PROBLEM

The old rubber buffer plates on the A62 and A71 are too thin.

SOLUTION

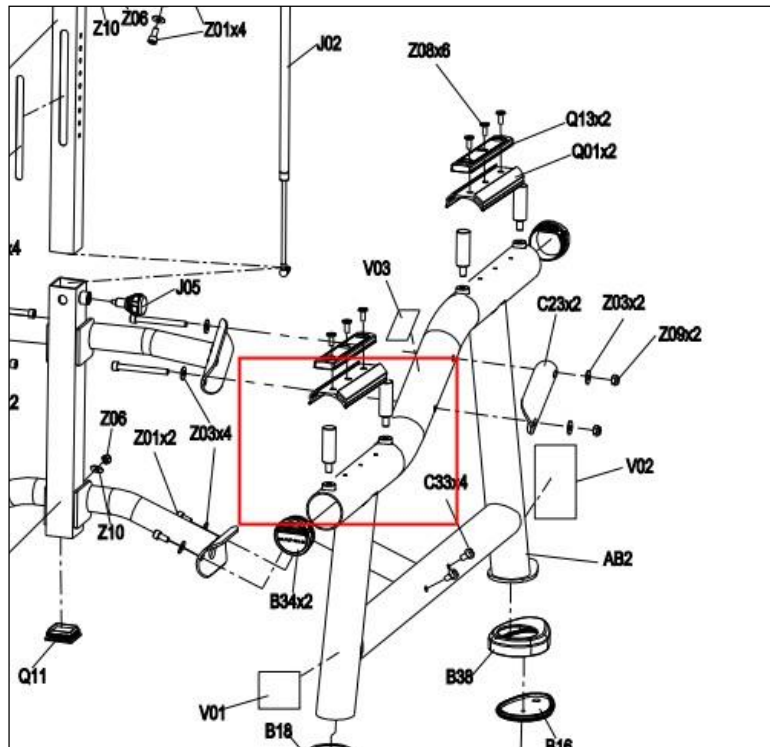
Below are the parts for the FW224 (A62) rework solution:
 Q02 2pcs Q03 2pcs Z01 6pcs AB1 1pc

Below are the parts for the FW213 (A71) rework solution, **per side**:
 Q13 4pcs Z08 12pcs AB2 1pc
